UNITED STATES PATENT AND TRADEMARK OFFICE

APPLICATION NO.	FILING DATE	FIRST NAMED INVENTOR	ATTORNEY DOCKET NO.	CONFIRMATION NO.
10/739,412	12/19/2003	Martin Gagnon	01093-106	1694
7590 Ronald S. Kosie BROUILLETTE KOSIE PRINCE 25th Floor 1100 Rene-Levesque Boulevard West Montreal, H3B 5C9 CANADA			EXAMINER DUONG, THO V	
			ART UNIT 3744	PAPER NUMBER
SHORTENED STATUTORY PERIOD OF RESPONSE	MAIL DATE	DELIVERY MODE		
3 MONTHS	02/23/2007	PAPER

Office Action Summary	Application No.	Applicant(s)
	10/739,412	GAGNON ET AL.
	Examiner	Art Unit
	Tho v. Duong	3744

FIGURE A: The modified figure corresponds to figure 2 of Hossfeld with limitation shown

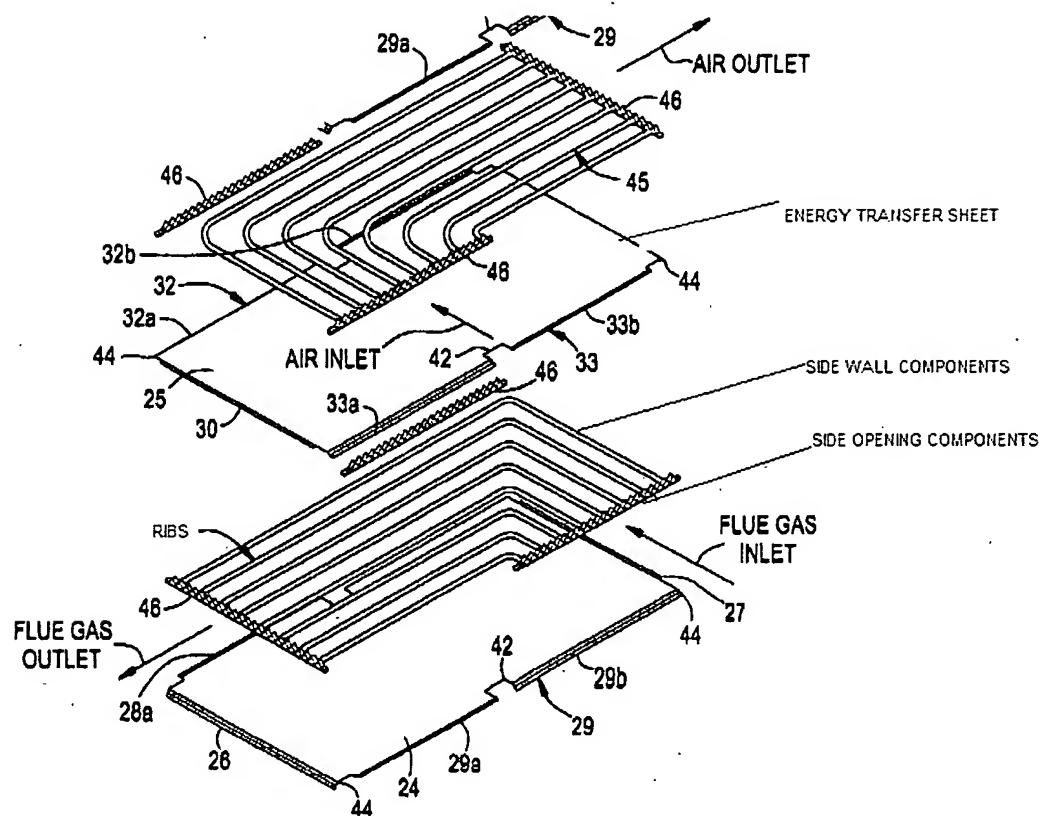
Claims 1 and 5-7 are rejected under 35 U.S.C. 102(b) as being anticipated by Hossfeld (US 6,059,025). Hossfeld (figure 2 and A as bellow) discloses a hexagon heat exchanger with all of the claimed limitations.
